Airworthiness Directives; Eurocopter France Model AS350B, BA, B1, B2, B3, C, D, and D1; EC–130B4; and AS355E, F, F1, F2, and N Helicopters

ACTION: Notice of proposed rulemaking (NPRM).

Eurocopter France: Docket No. FAA-2007-27495; Directorate Identifier 2005-SW-14-AD.

Figure 1

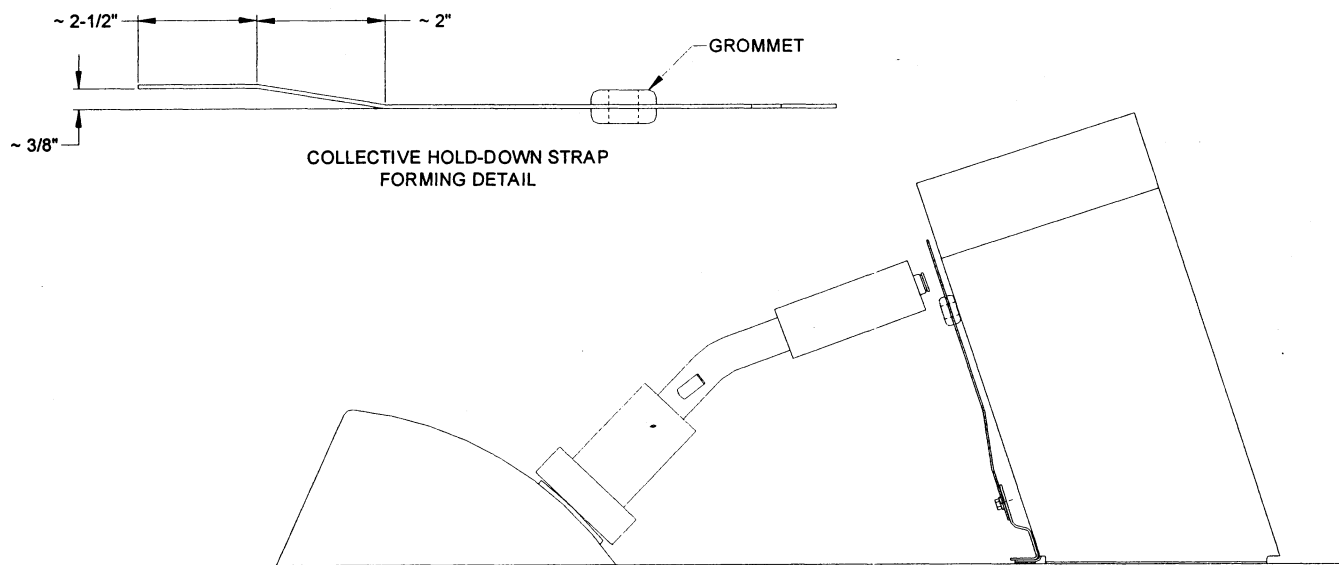
- (a) Within the next 30 days, unless accomplished previously, modify the strap by forming the strap as depicted in Figure 1 of this AD. Install the modified strap so that the rubber grommet rests against the console. Thereafter, at intervals not to exceed 100 hours time-in-service, inspect the strap to ensure that the rubber grommet is resting against the console.

To ensure that the strap does not inadvertently lock the collective during normal operation, the strap must be formed by joggling it as shown in the figure. When formed correctly, the strap will naturally touch the console aft wall, requiring it to be flexed in order to lock the collective.
